Viking CCS Pipeline

9.41 Design Changes 5 to 8: Environmental Technical Note

Document Reference: EN070008/EXAM/9.41

Applicant: Chrysaor Production (U.K.) Limited,
a Harbour Energy Company
PINS Reference: EN070008
Planning Act 2008 (as amended)
The Infrastructure Planning (Applications: Prescribed Forms
and Procedure) Regulations 2009 - Regulation 5(2)(q)
Date: June 2024

- LEGEND**
- Revised DCO Site Boundary (June 2024 Submission)
 - Route Section Break
 - Dune Isolation Valve
 - Temporary Construction Compound
 - Block Valve Station
 - Theddlethorpe Facility

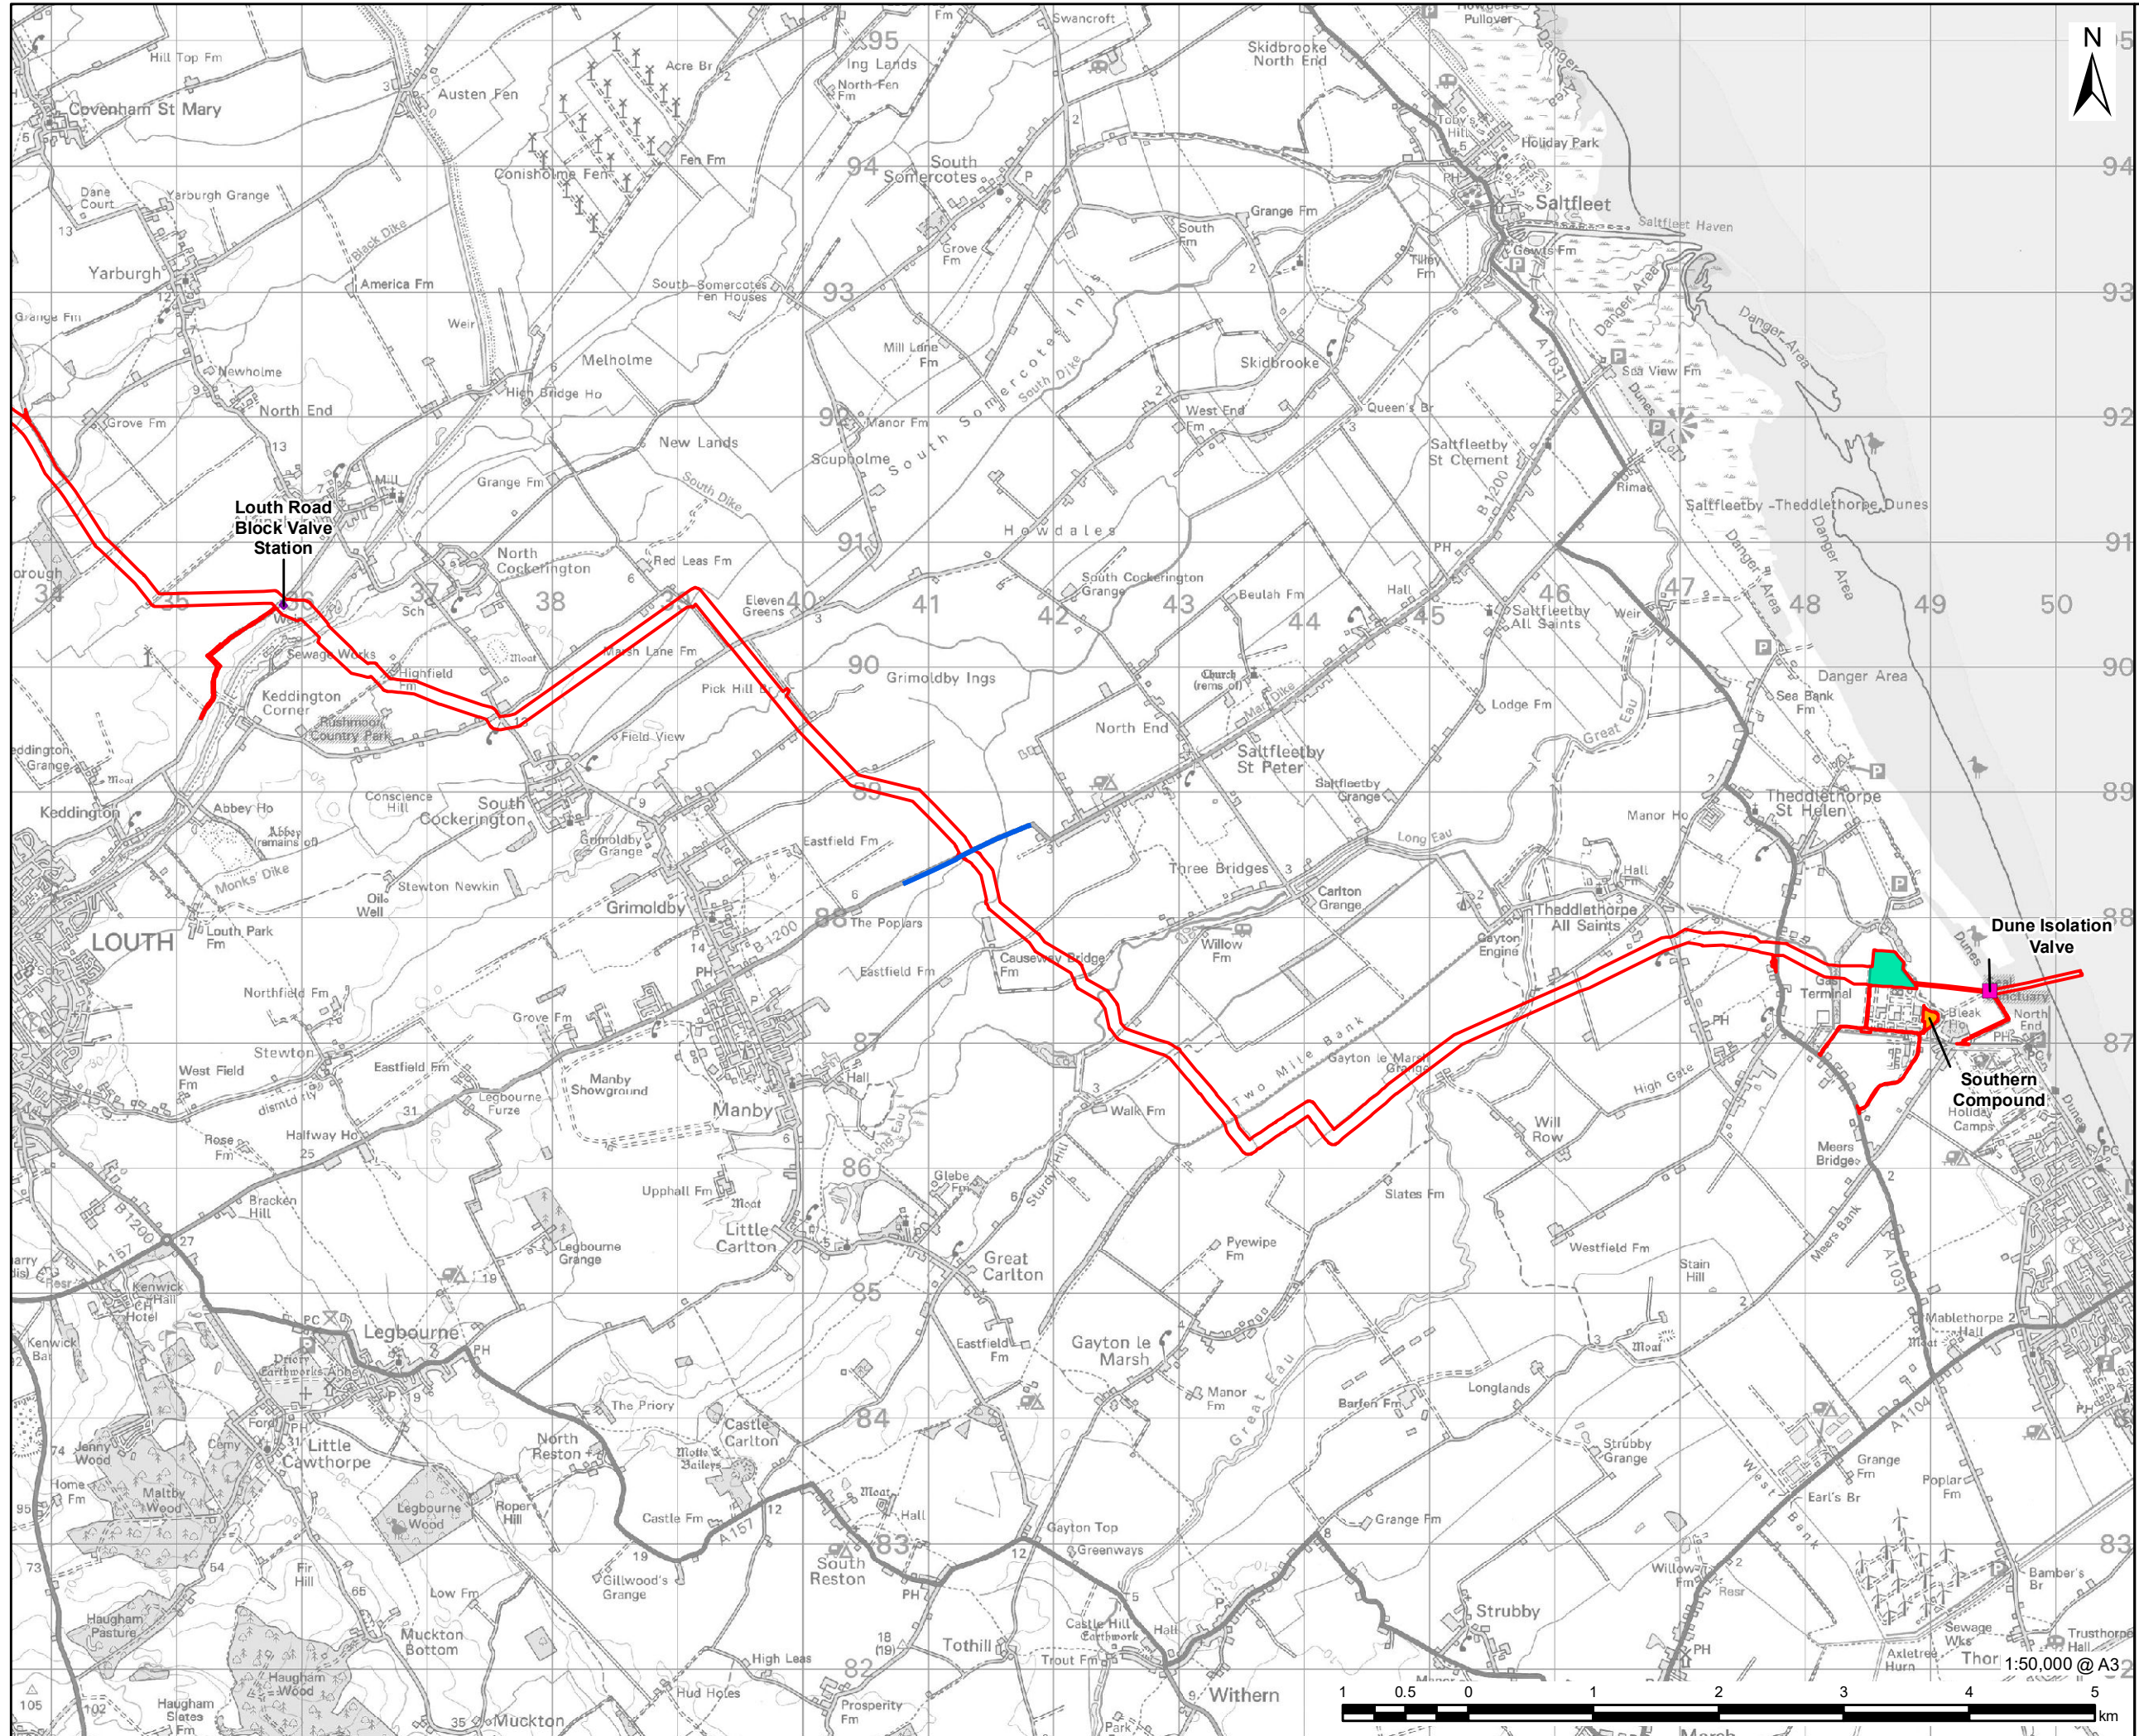
2.6.1 **Figure 5** presents the updated Order Limits/DCO Site Boundary for the proposed Development, taking into account the proposed design changes 3 to 8.
